TRANS/WP.29/733
5 May 2000

World Forum for Harmonization of Vehicle Regulations (WP.29)

DRAFT SUPPLEMENT 3 TO REGULATION No. 91

(Side-marker lamps)

Annex 3, Example 1 (a) ,amend to read:

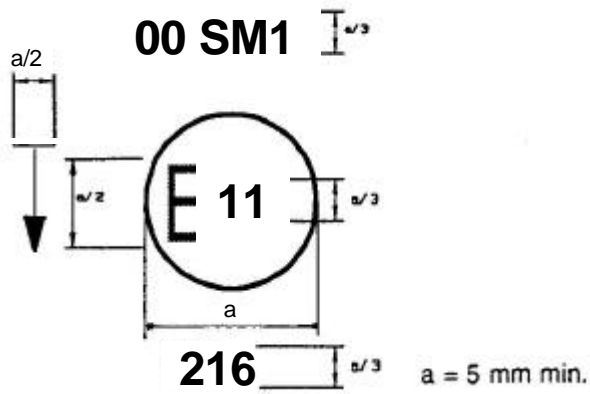
Annex 3, add a new sentence at the end of the caption below the figure, to read:

".... number 216. The vertical arrow starting from a horizontal segment and directed downwards indicates a permissible mounting height of equal to or less than 750 mm from the ground for this device.
